NOTICE

ZONING BOARD OF APPEALS (ZBA) MEETING

TUESDAY, NOVEMBER 21, 2023 AT 6:30 PM

EXHIBIT C

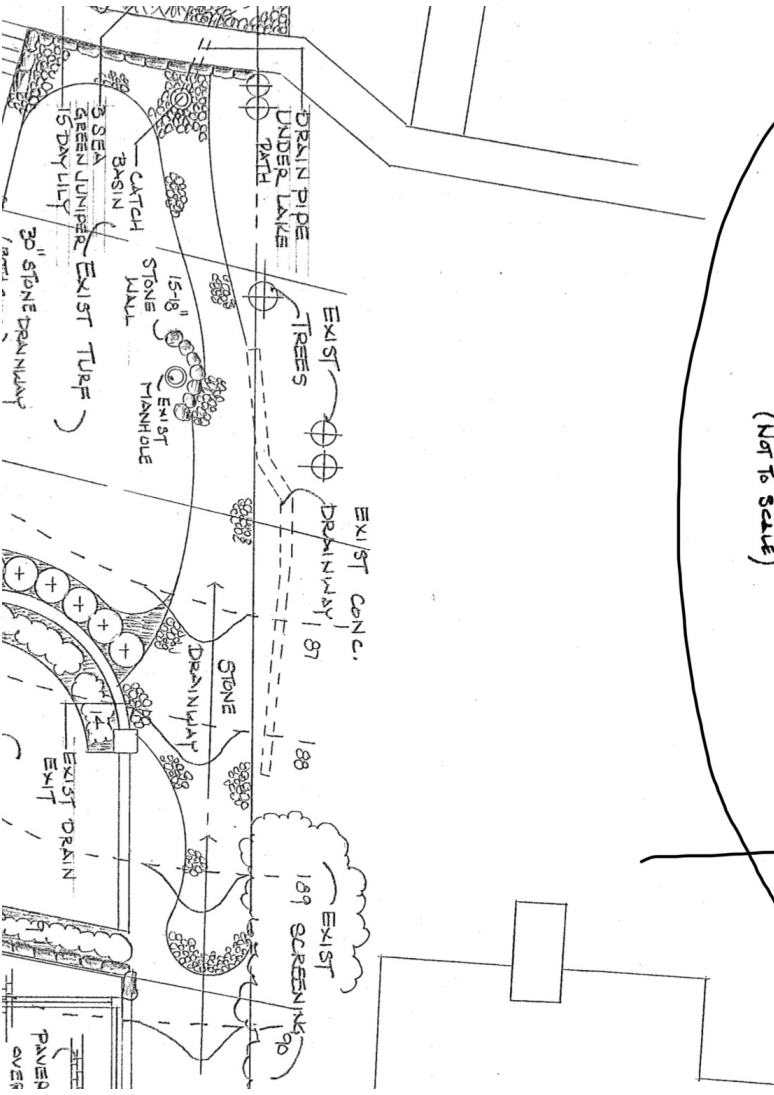
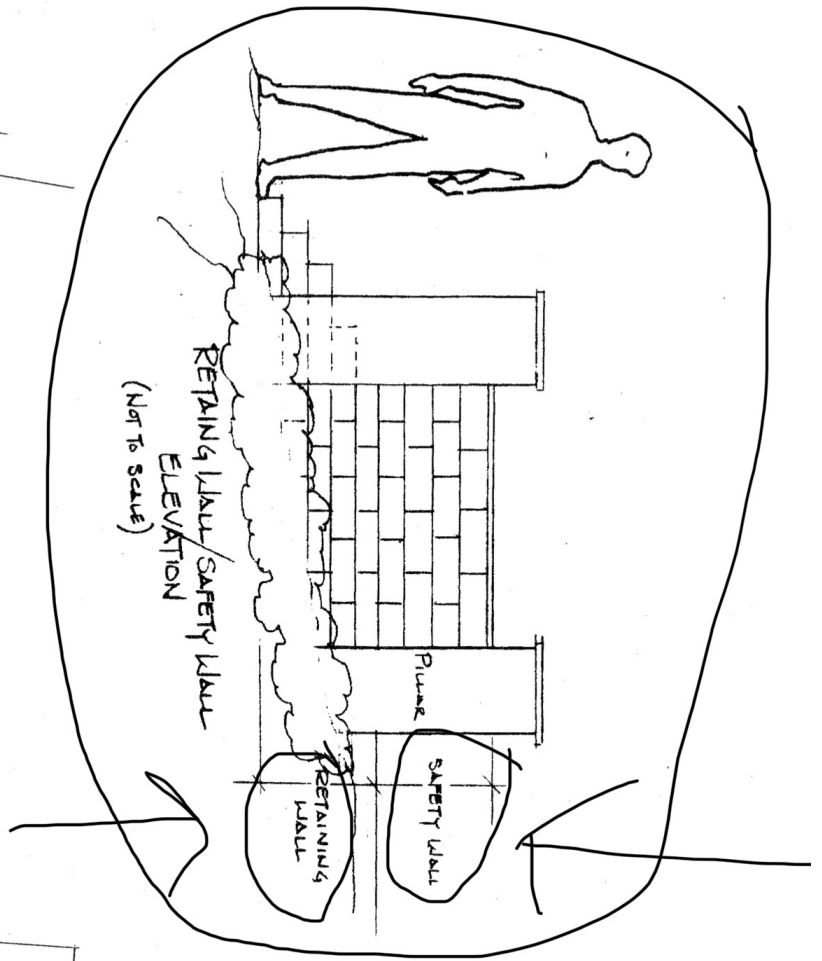
Following up on my email message and photos sent to you on the morning of June 23, 2023, I have received no response to my stated concerns that the work at 226 Circle Parkway does not appear to follow the plan provided to us by the Village on March 22, 2023, in response to our formal request made when the exterior work began. The height of the concrete wall has grown since that date, and as the attachments to this message indicate, the retaining wall PLUS safety wall is not supposed to exceed the chest height of a person, based on the plan the Village provided to us. We raised further concerns last October that any plan should be drawn professionally to scale.
